Modification Report | Section 4.55(1A) Modification Application to SDD-8925 New Sydney Fish Market, Bridge Road, Glebe.

This application has been prepared by Ethos Urban on behalf of Multiplex Constructions Pty Ltd, pursuant to section 4.55(1A) of the *Environmental Planning and Assessment Act 1979* (EP&A Act) to modify State Significant Development Consent SSD-8925 relating to the new Sydney Fish Market (SFM) Stage 2 at 1A, 1B and 1C Bridge Road, Glebe.

The modification relates to a proposed change of the approved road level of Bridge Road involving the reduction of height of Bridge Road by a metre (to a level similar to its existing level), and as a result amendments to the height of bus/taxi bays, and landscaping across the Bridge Road frontage of the Sydney Fish Markets.

Figure 1 Sectional comparison of approved (red) and amended road design (black)

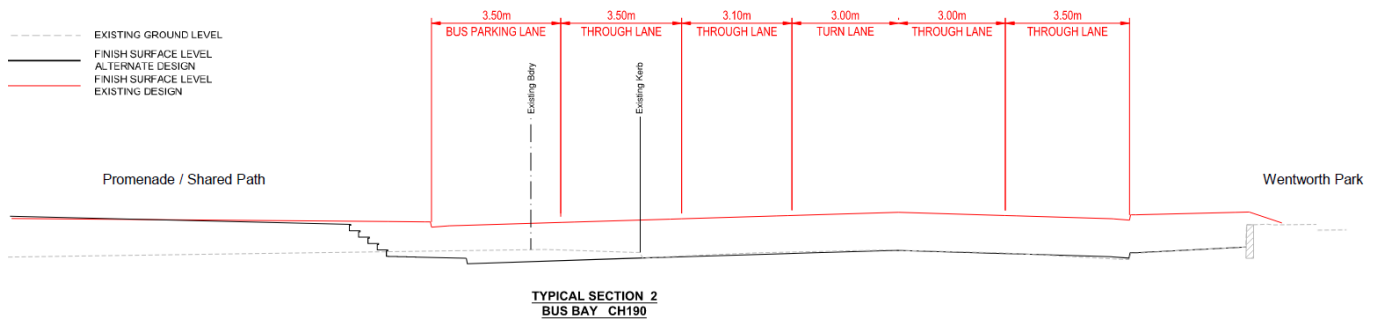
SSD-8925 approves the raising of the existing Bridge Rd carriageway by approximately 1.2 metres along the site frontage to approximately RL 3.1m AHD. This modification seeks to reduce this level by approximately the same distance, leaving the final Bridge Road level generally the same as that which currently exists (approx. RL 2.0m AHD). This is indicatively illustrated in **Figure 1**.

Figure 2 Comparison of approved (top) and amended road design (lower)

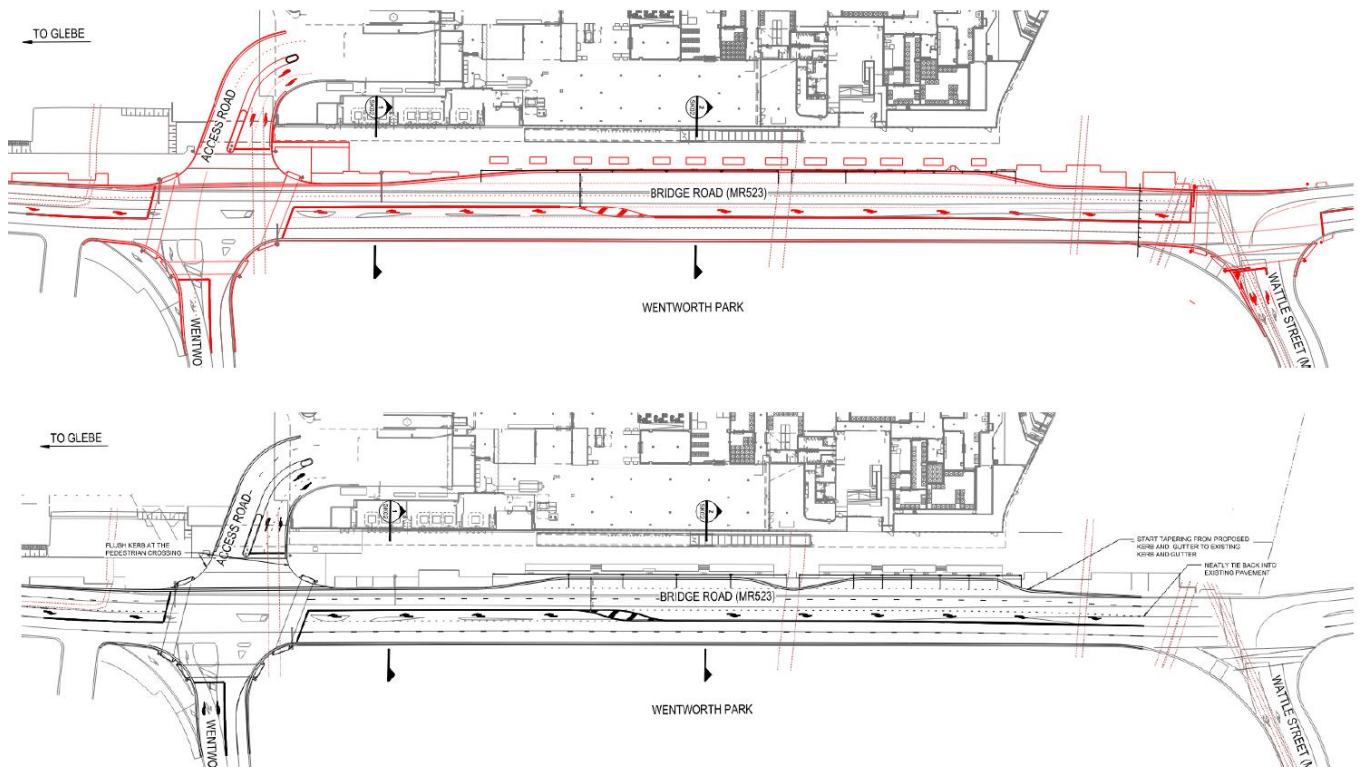
A minor change to the road design layout, involving the retention of the existing northbound left-turn lane configuration from Wattle Street (and adjoining wall to Wentworth Park) is accommodated by the retention of the existing levels (**Figure 2**).

Figure 3 Outline of the Bus Bay (orange) and Taxi and Ride services bay (green)

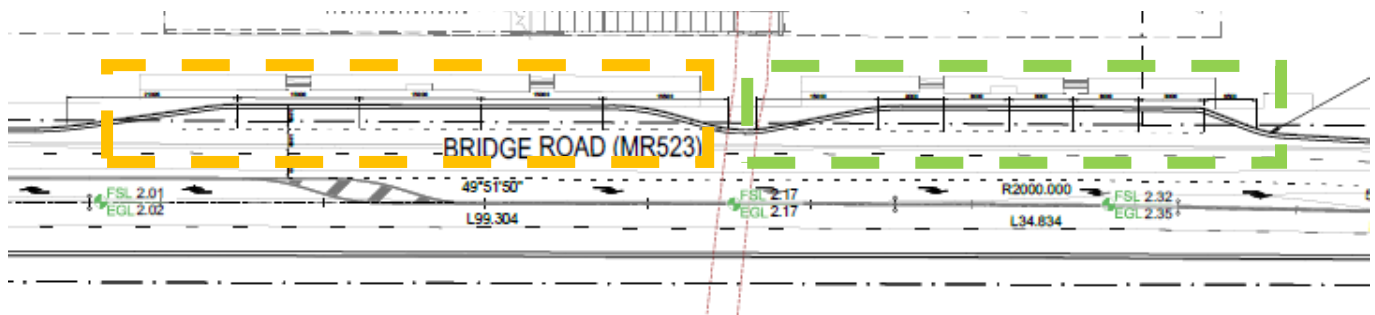
The location of the approved bus bays will remain on Bridge Road; however, the modification seeks to propose a separation of the singular bus bay into two bays, with the southern bay is dedicated to bus and coaches whilst the eastern bay is dedicated to taxi and ride-share services as seen in **Figure 3** below. The southern bay dedicated to coaches is proposed to be 45m in length which the eastern bay is proposed to be 40m long. Pedestrian set-down/pickup areas, ramps/stairs and landscaping are illustrated in **Figure 4**.

Figure 6 Proposed landscaping and access from Bridge Road to the shared zone

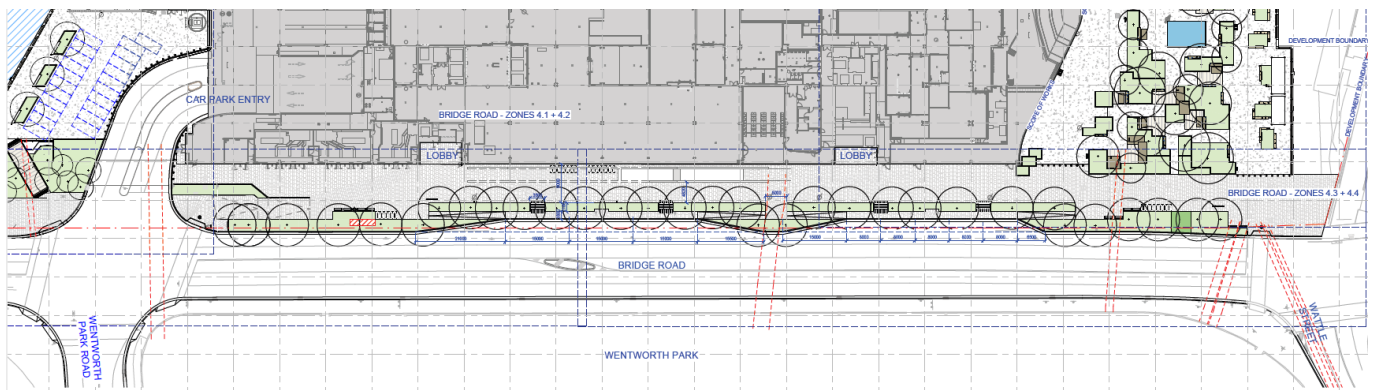
The approved shared zone that sits adjacent to the southern boundary of the approved Fish Markets building will remain at the approved height, creating a metre difference from Bridge Road to the shared zone. As a result, the modification seeks to propose new ramps, stairs, planting and seating zones to provide a connection between Bridge Road and the shared zone as seen in **Figure 6** below.

Four stairs and four ramps are proposed along the drop off and pick up bays to provide access to the shared zone. Furthermore, additional planting, landscaping, wheelchair access and waiting zones are proposed between Bridge Road and the shared zone. The proposed landscaping will utilise the plants outlined within the planting schedule in the approved EIS.

Figure 8 Indicative construction forecast comparison.

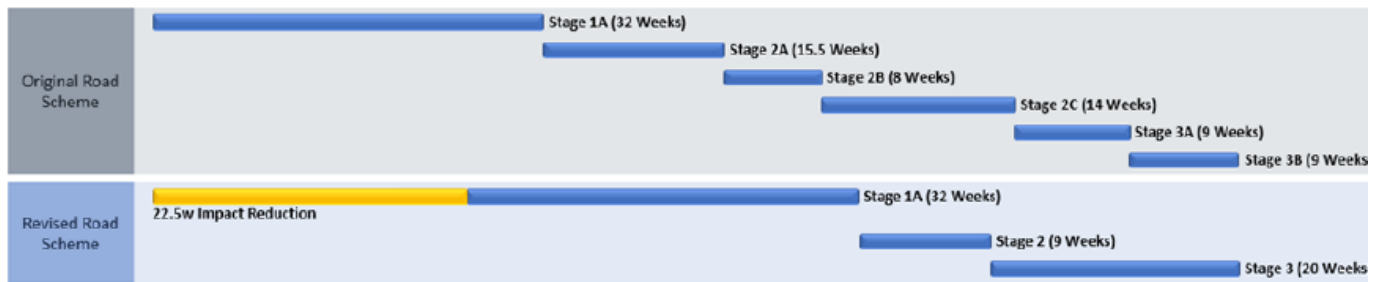
The proposed modification will reduce the construction timeframe by approximately 22 weeks (as seen in **Figure 8**), which will provide relief to surrounding residential receivers and commuters who utilise Bridge Road by reducing the duration of impacts on the transport network and duration of construction impacts for the community.
